**SECTION 00 90 03  
BIDDING AND CONTRACT REQUIREMENTS  
ADDENDUM NUMBER 3**

**Re: ADDENDUM NUMBER (3) TO THE BIDDING DOCUMENTS FOR**

**Student Farm Renovations  
Issued for Bid**

Architect's Project Number: 25-037

SHEET NUMBER:  
**A11.01**

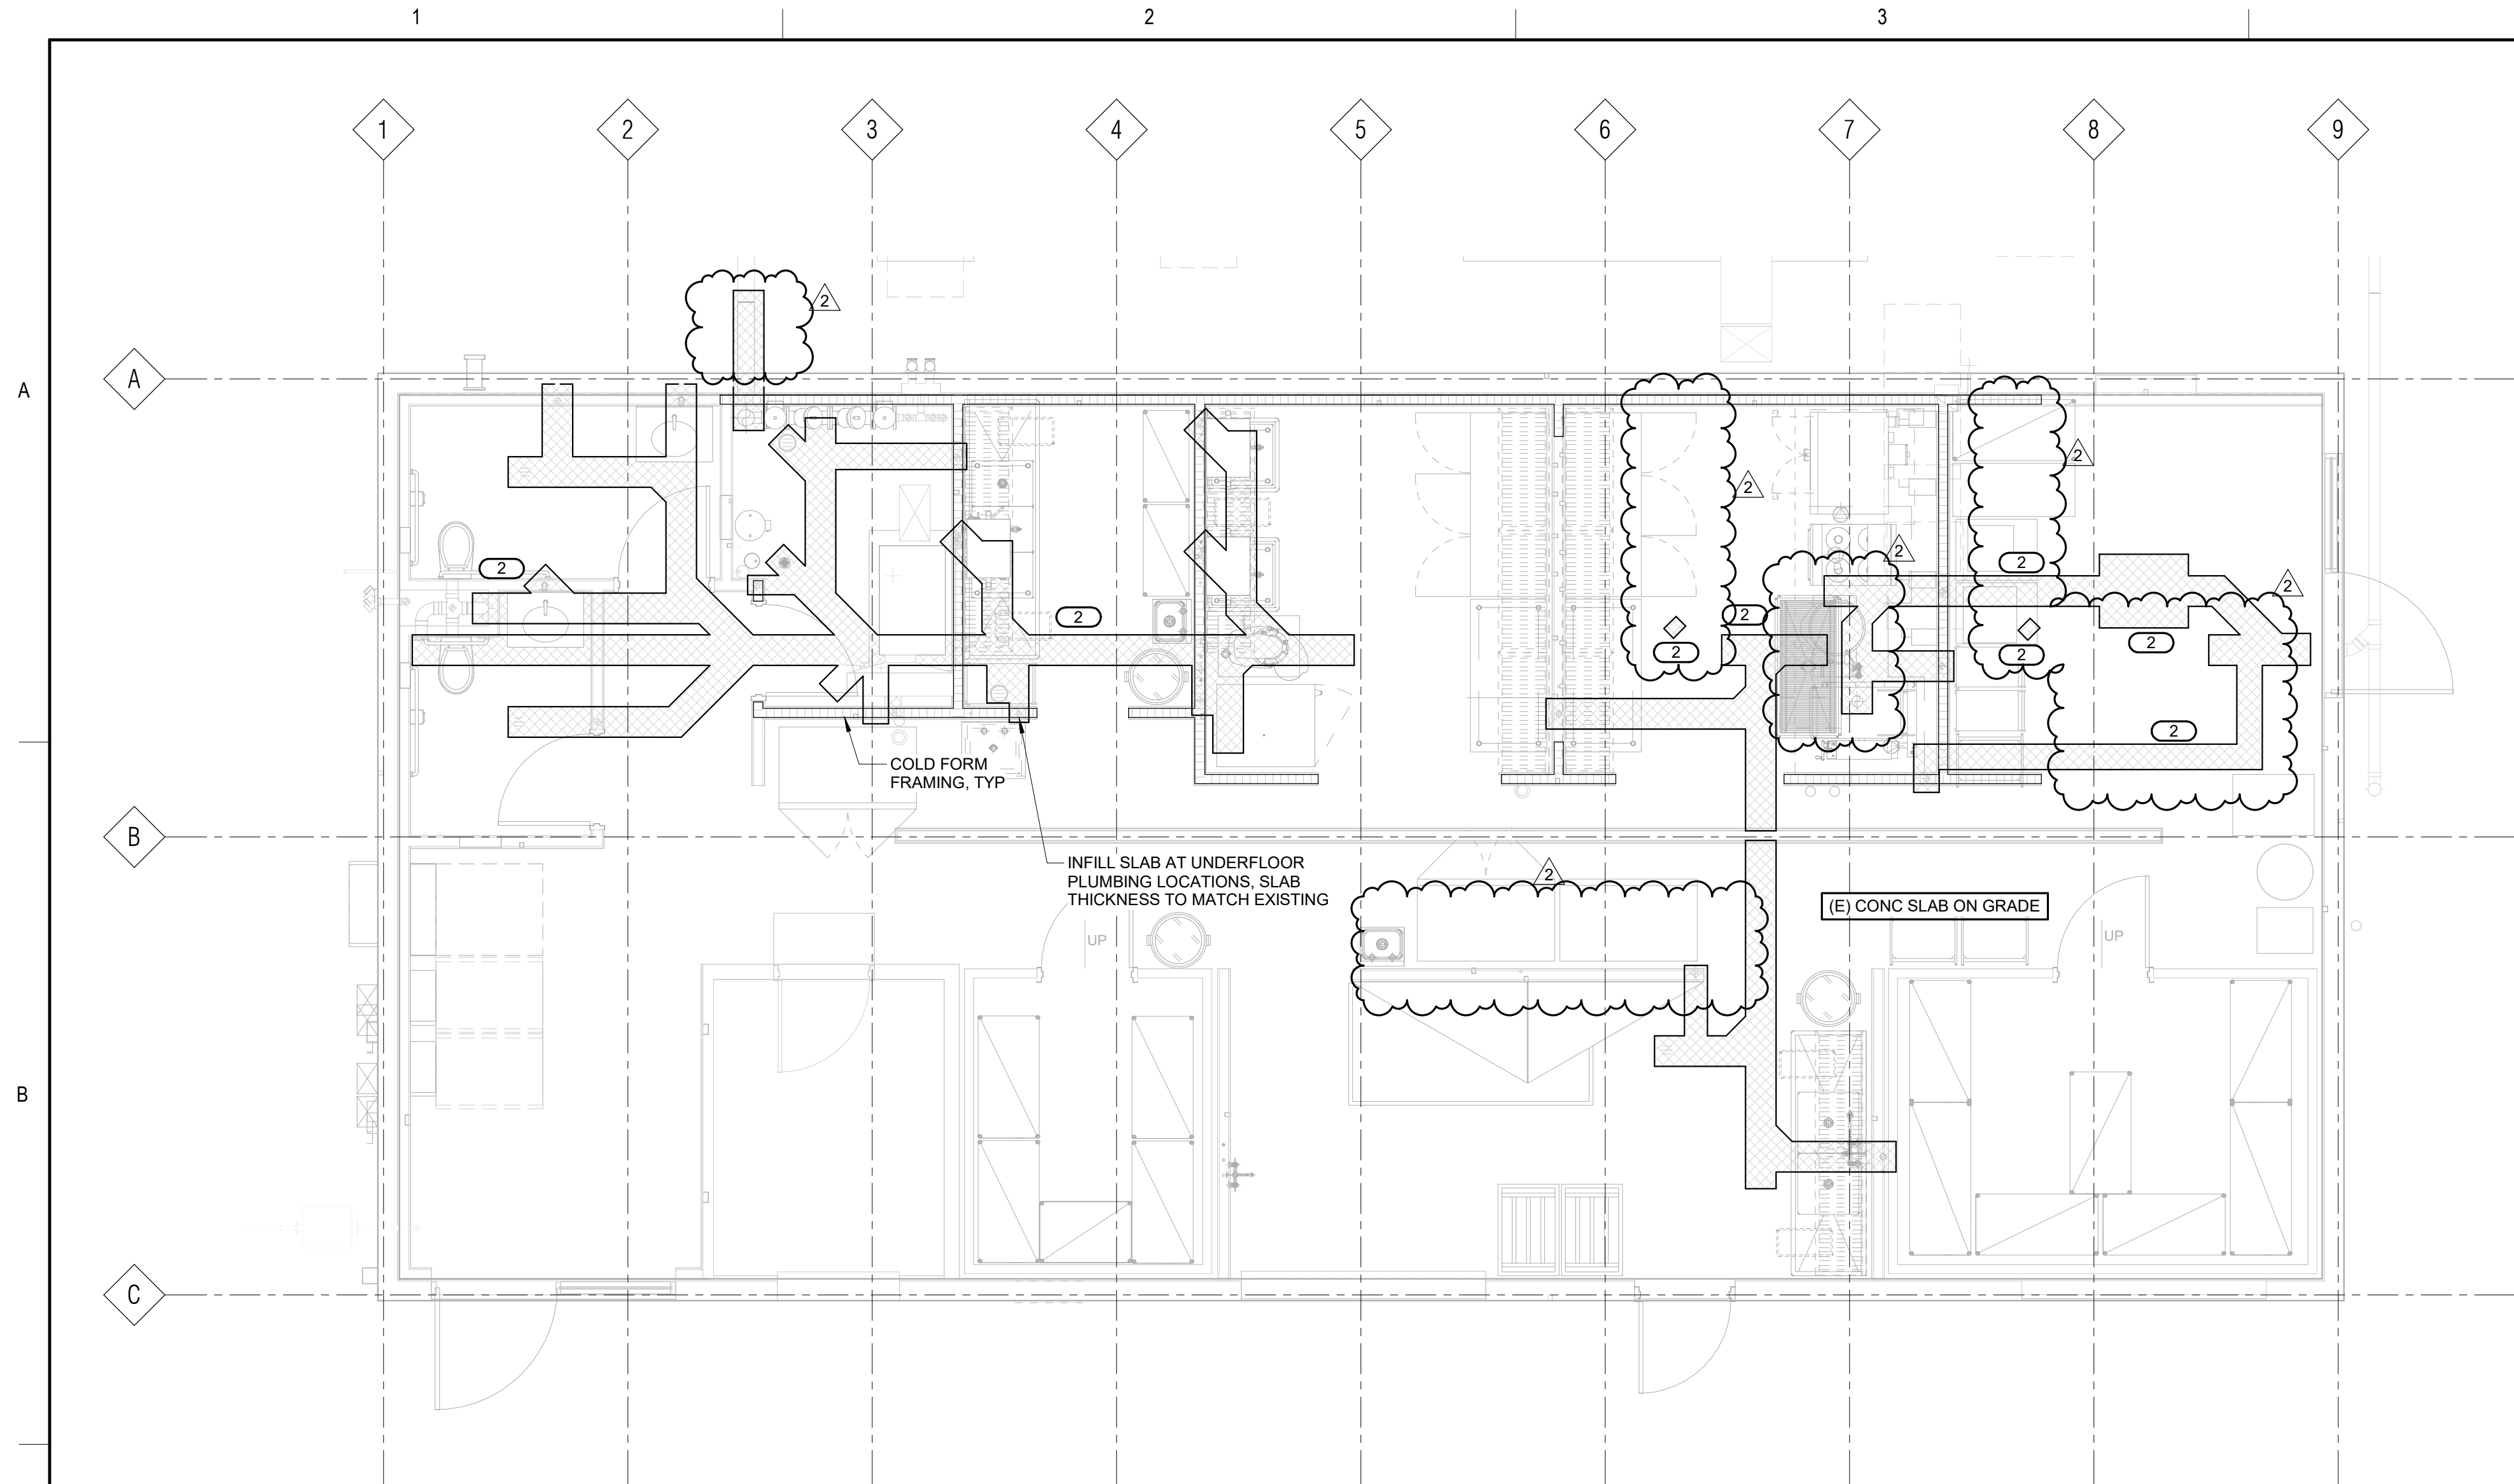
- C. **REVISE** door tags as shown on schedule.
  - D. **REVISE** Window Elevation A to show frame typ. frame width
4. A11.01
  - A. **REVISE** Finish Plan General Notes to include paint color as indicated.

- B. **ADD** PT-01 paint color as indicated.
  - C. **ADD** PT-02, FRP-02, SS-01 to wall type legend and finish plan and clarified height extents of the FRP paneling.

- D. **REVISE** wall base type as indicated.
  - E. **REVISE** floor finish type for sealed concrete.
  - F. **ADD** corner guard information to legend and finish plans.

- G. **REVISE** note 1 as indicated.

- A. RESPONSE: FRP should be 10' H (or less where lower ceilings are located) and installed full height throughout the space above the wall base.
10. PRE-BID RFI #18: There is a specification for wall and corner guards, but none shown on the floor plan. Are we to include corner guards? If so, what locations?

- A. RESPONSE: Refer to attached revised finish plans for corner guard locations, types, and heights.
11. PRE-BID RFI #19: Can you clarify the following items related to temporary fencing for this project...

**1 FOUNDATION PLAN**  
1/4" = 1'-0"

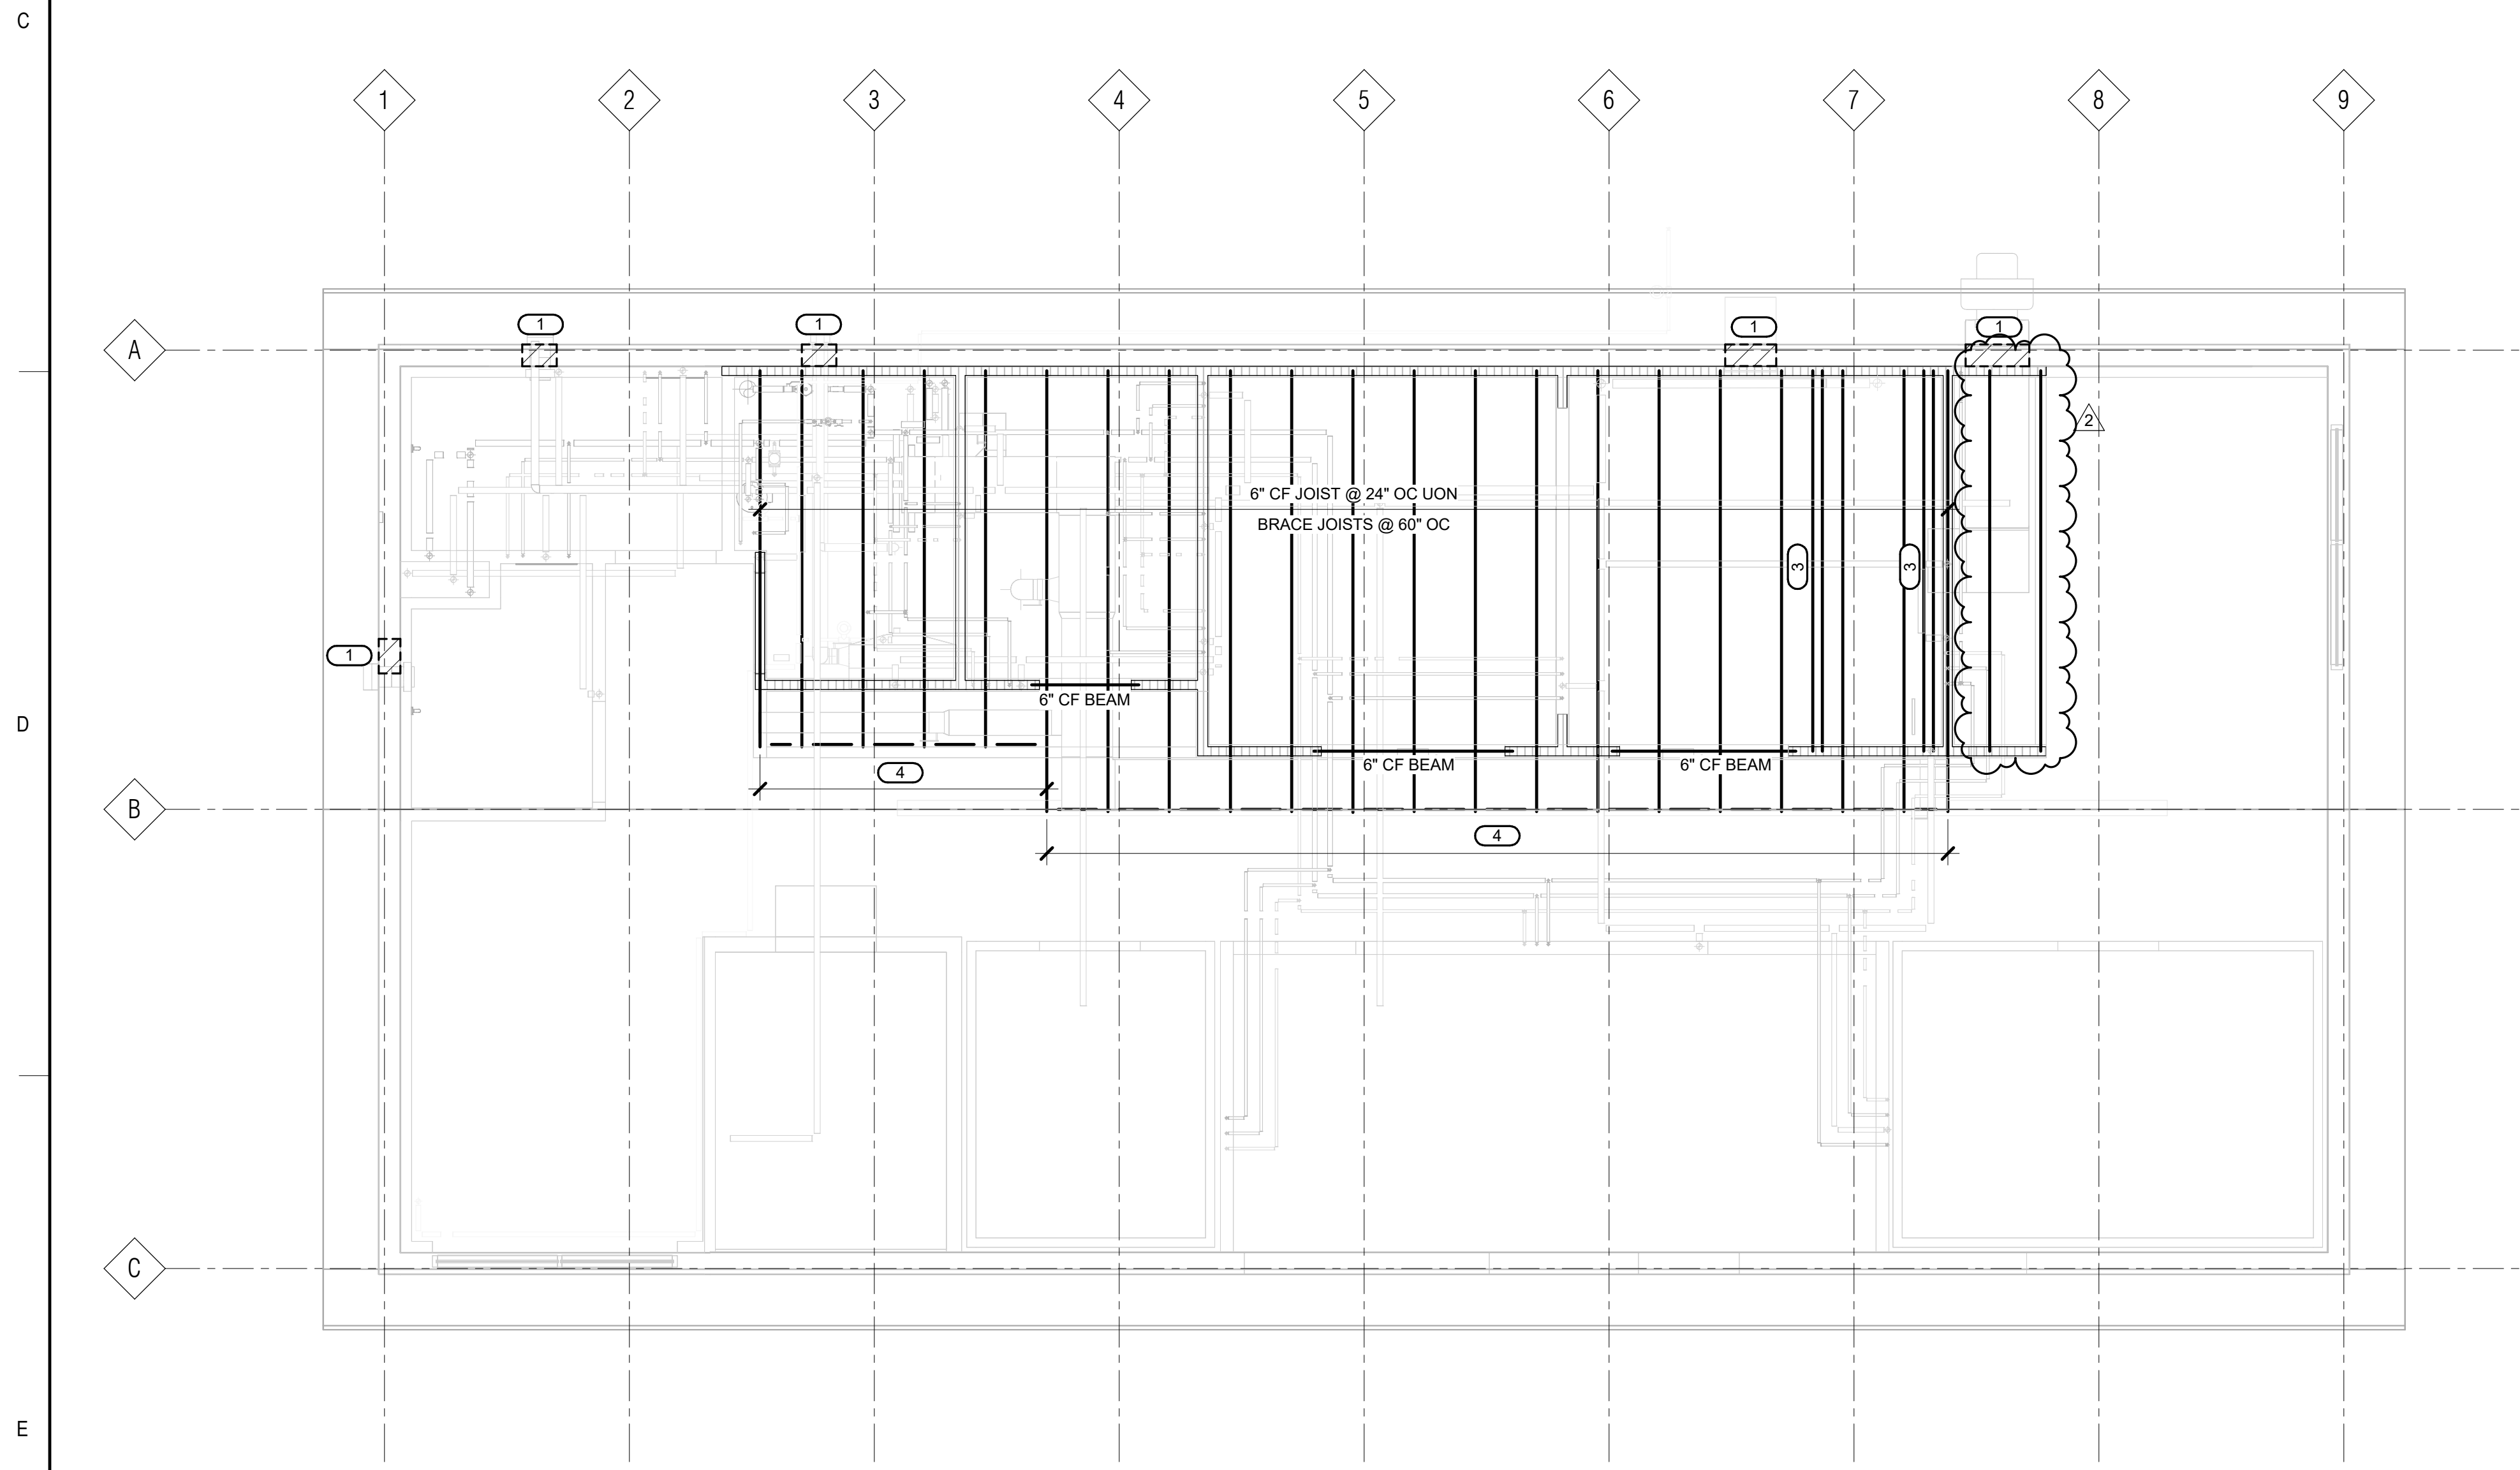
1. S1.00
  - A. **REVISE** slab infill per revised underfloor plumbing drawings.
  - B. **ADD** bearing wall and joists to support revised ductwork layout.
